Access Report

PLH Ashton

23-25 Ashton Avenue
THE ENTRANCE NSW

Ref: PAA_23122

Figure 2 | Overall Site Plan

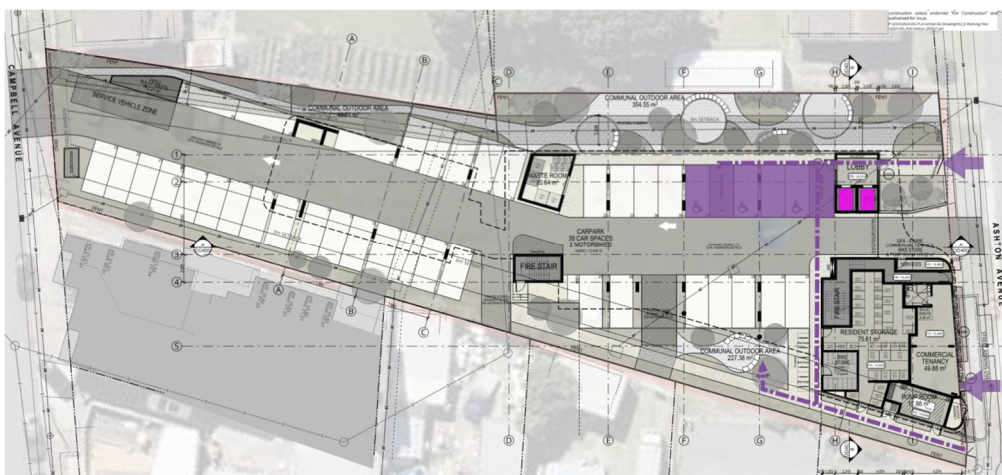
An accessible path of travel is provided to the building entrance from the allotment boundary along Ashton Avenue via a formed footpath. Site levels indicate that on-grade access is achievable.

An accessible path of travel is provided to the building entrance via a formed footpath. Site levels indicate that on-grade access is achievable.

Footpaths that form the approach to the building and external areas generally, are a minimum of 1220mm wide. Site levels indicate a level surface is achievable.
